KENTUCKY-AMERICAN WATER COMPANY
CASE NO. 2014-00258
COMMISSION STAFF'S SECOND REQUEST FOR INFORMATION

REVISIONS		RRS FILTER BUILDING IMPROVEMENTS STRUCTURAL PIPE GALLERY GENERAL NOTES
		KENTUCKY AMERICAN WATER CENTRAL SERVICE AREA
		AMERICAN WATER ENGINEERING 3906 CHURCH ROAD MT. LAUREL, NJ 08054 DRAWN BY R. BEATTY PROJECT ENG'R J. JIMENEZ APPROVED
		 DATE 2-25-13 PROJECT #### USE DIMENSIONS ONLY SCALE 3/16" = 1'-0"
		USE APPROVED DRAWINGS ONLY FOR CONSTRUCTION PURPOSES
		120201-0017-S0

RRS FILTER BUILDING IMPROVEMENTS
 STRUCTURAL
 PIPE GALLERY
 PLAN

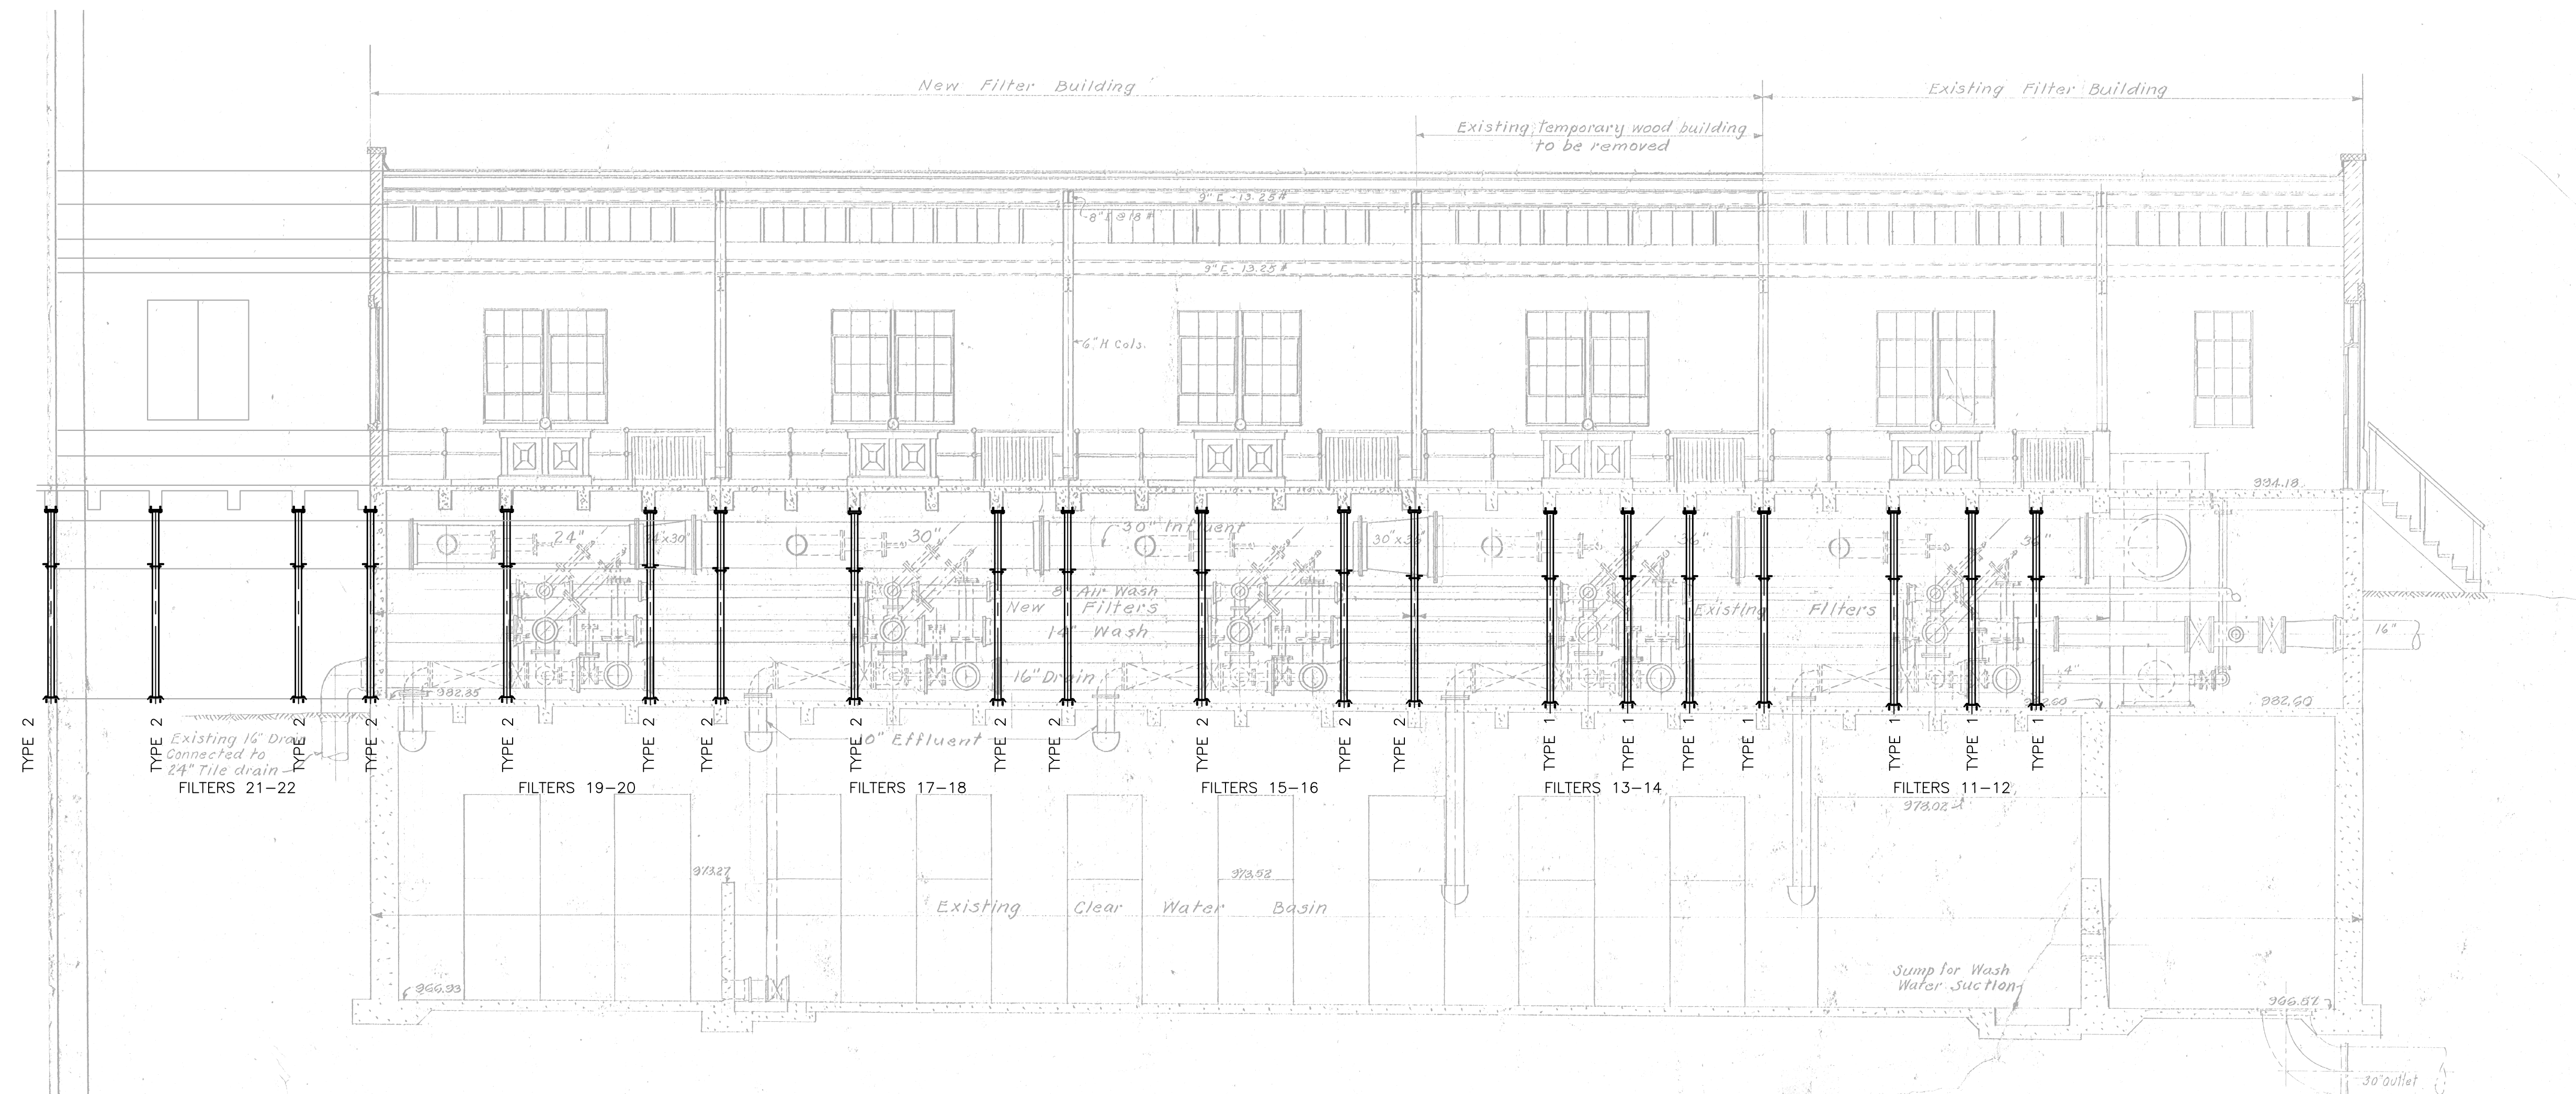
- b. Provide a copy of each of the two file attachments to the February 28, 2013 e-mail message, "Structural Dwgs Set.pdf" and "Cost Estimate.pdf."
 - c. The e-mail message includes the following statements. "The CPS indicated that repairs on the order of \$500,000 would be required to repair pipe supports, concrete beams, floor slabs and cracks in the concrete tank walls. This approach, as outlined in the report, was comprehensive in that it provide for repairs to last 20+ years and covered more than just pipe hanger supports. It was intended to prolong the life of the entire structure and assumed the facility would remain in service for the next 20+ years." Explain whether the approach identified and outlined in the CPS Report is sufficient to restore and maintain the integrity of the structure so as to avoid any likely structural failure in the building. If not, explain why not.

- b. Copies of the two file attachments to the February 28, 2013 email from Andy Higgins are attached.
- c. The project being discussed in the February 28, 2013 email message from Andy Higgins was a proposed project that would provide an intermediate solution to the structural problems, but, because it would not eliminate the corrosive environment, it would not be a long-term solution to prevent structural failure. It was a project proposed within the draft January CPS that involved structural improvements to the existing clearwell. The identified project was to repair and reinforce 24 concrete beams, recoat the concrete roof slab and replace the pipe hangers for the 36-inch filter influent pipe. The project was considered an intermediate effort to extend the life of the existing facility and address the safety concerns identified. The suggested project addressed the major structural

As a result of the removal of the project from the draft CPS, the alternative design costing \$118,000 that is discussed in the February 28, 2013 email was developed to address the immediate safety issues and provide time to further investigate and plan the replacement of the filter building. The "Structural Dwgs Set.pdf" and "Cost Estimate.pdf" attached in item b above are from the development of the alternative design.

- b. As discussed in the response to Item No. 8 of the Commission Staff's First Request for information, Kentucky American Water installed 17 floor-mounted pipe supports and cross members to temporarily enhance existing pipe supports for 30-inch and 36-inch diameter cast iron raw water pipe, and to support severely corroded floor slab beams during June 2013. These measures were outlined in the Structural Drawing Set that was attached to the February 28, 2013 email.
